Department of City Planning

June 15, 2020

SUPPLEMENTAL RESPONSES TO LETTERS FROM THE APPLICANT DATED MARCH 9, 2020, AND APRIL 30, 2020, AS ADDITIONAL INFORMATION TO THE STAFF RECOMMENDATION REPORT FOR CASE NO. CPC-2017-3251-TDR-MCUP-SPR; 1045 OLIVE STREET

Figure 1 - Lot Area and Buildable Area

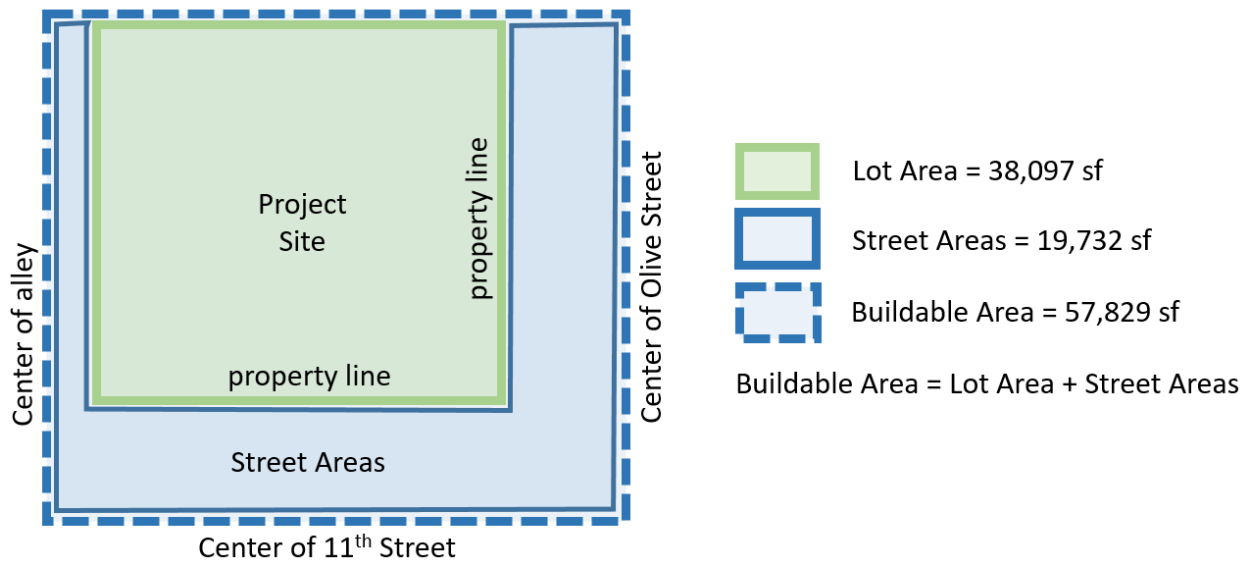
The maximum allowable floor area allowed under TFAR could be up to thirteen times the Lot Area. However, the maximum desired floor area can be further increased if a Project qualifies as a Transit Area Mixed Use Project. In that case, the maximum allowable floor area rights may be increased based on Buildable Area, rather than Lot Area. Buildable Area, for a Transit Area Mixed Use Project, is defined as the Lot Area, "plus the area between the exterior lot lines and the centerline of any abutting public right-of-way". The following diagram showcases the difference between Lot Area and Buildable Area, where Buildable Area combines Lot Area and Street Areas.

As stated above, by-right floor area is based on Lot Area. However, the TFAR ordinance is unique in that the maximum floor area attainable under the ordinance is calculated using Buildable Area for projects located in transit areas. This allows a project to include areas to the center line of adjacent streets. However to be clear, this additional area of inclusion has no base area rights to floor area. In this aspect, the Lot Area of the proposed project has a base floor area ratio of 6:1, and the additional area calculated out to the mid-point of the street has a base floor area ratio of zero. Through the TFAR process, both can go up to 13:1 and be built on the private parcel area. Essentially, this provides additional floor area benefits for Transit Area Mixed Use Projects, since these projects can use not only floor area rights from their Lot Area, but also floor area rights added from adjacent street areas. In other words, with a maximum Floor Area Ratio (FAR) of 13:1, the Project is permitted to calculate their maximum allowable floor area based on thirteen times the Buildable Area of the project site. The following diagram showcases how Lot Area and Buildable Area are utilized in the calculation of by-right and maximum allowable floor areas.

Figure 2 - Maximum By-Right and TFAR Floor Area

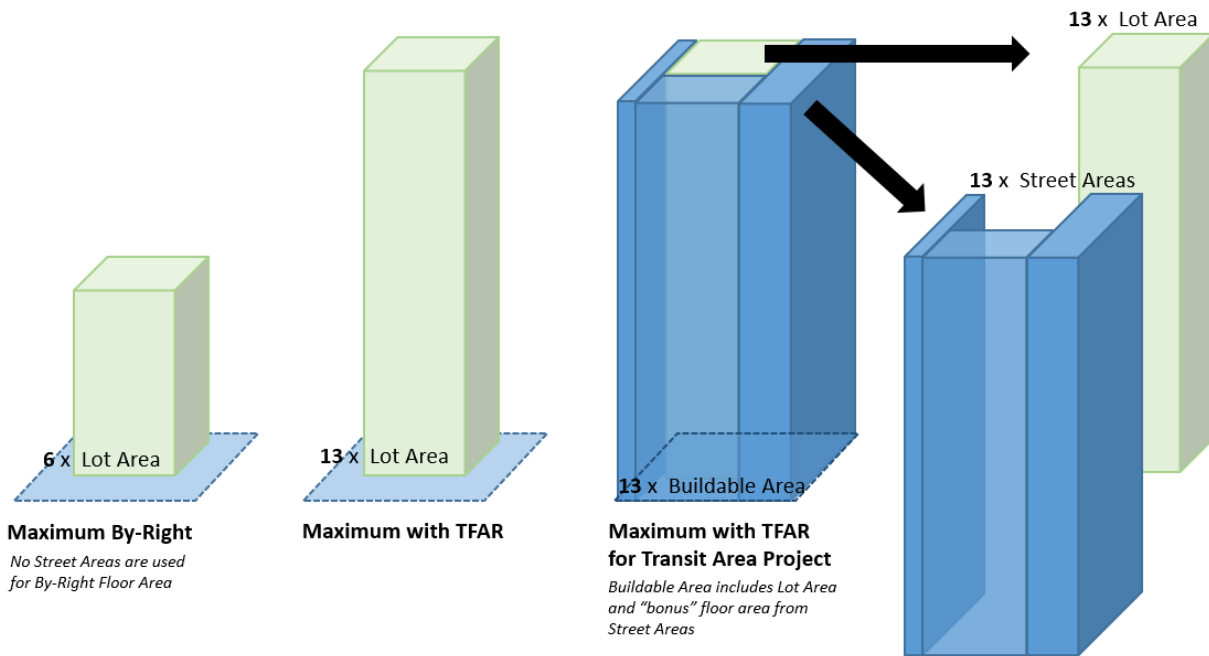
The maximum allowable floor area available to be transferred through a TFAR request is calculated as the difference between the Buildable Area at a 13:1 FAR and the Lot Area at a 6:1 FAR.

In the specific request for the Project, the calculation to determine the floor area available to be transferred to the Project is provided in the calculations below. However, in this case, the Applicant's representative falsely claimed that the entire Buildable Area, including the area to the mid-point of adjacent streets, had a base floor area ratio of 6:1, resulting in an undercount of necessary floor area to be transferred to build the proposed project, and a corresponding undercount of the required Transfer Fee and Public Benefit Fee calculations.

The Applicant's incorrect calculation results in a net difference of 118,392 square feet of floor area that should be accounted for as part of the Project's Requested Transfer Area. As proposed by the Applicant's calculation, the Project would effectively receive 118,392 square feet of floor area from the City for free. Since calculation of both the Transfer Payment and Public Benefit Payment rely on the Requested
